REQUEST Current Zoning: R-3 (single family residential)
Proposed Zoning: UR-1(CD) (urban residential, conditional)

LOCATION Approximately 7.69 acres located on the west side of Steele Creek Road, south of Hamilton Road.
(Outside City Limits)

SUMMARY OF PETITION The petition proposes to allow a new 32-unit townhouse community on land with single family homes and vacant acreage in southwest Charlotte at a density of 4.2 dwellings per acre.

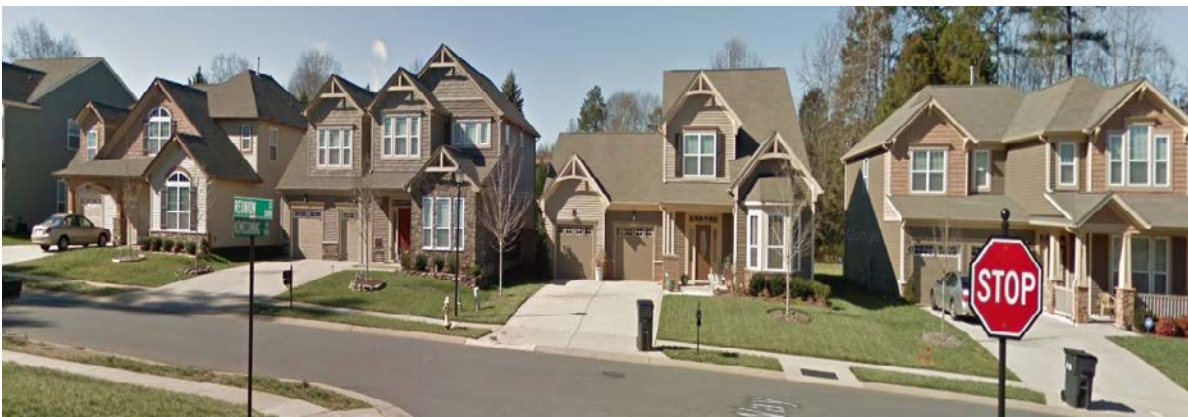
1. ~~The proposed zoning district has a setback measured from back of the existing or proposed future curbline. The proposed cross section for the NCDOT widening project U-5766 has been updated. Based on the new cross section, the location of the future back-of-curb for:~~ **Addressed**

- a. ~~Steele Creek Road — 42 feet from centerline of the road (reduced from 53 feet)~~
 - b. ~~Hamilton Road — 20.5 feet from centerline of the road (reduced from 28 feet)~~

2. ~~Revise the site plan to show:~~
 - a. ~~The back of multi-use path on Steele Creek Road located 65.5 feet from centerline of the road.~~ **Addressed**

- b. ~~The back of multi-use path on Hamilton Road located 40.5 feet from centerline of the road.~~
3. ~~The right-of-way for Steele Creek Road is shown incorrectly on the updated site plan. Furthermore, the updated cross-section for the NCDOT widening project U-5766 has changed the right-of-way. The petitioner should revise the site plan and conditional notes to show the dedication of right-of-way, fee simple, of 66 feet from centerline of Steele Creek Road (reduced from 75 feet).~~ **Addressed**

4. ~~Revise the site plan to show the correct existing right-of-way on Hamilton Road of 60 feet wide total, 30 feet from centerline of the road.~~ **Addressed**

5. ~~Reduce the building height to no greater than 40 feet so as to be in character with nearby single family residential neighborhoods.~~ **Addressed**
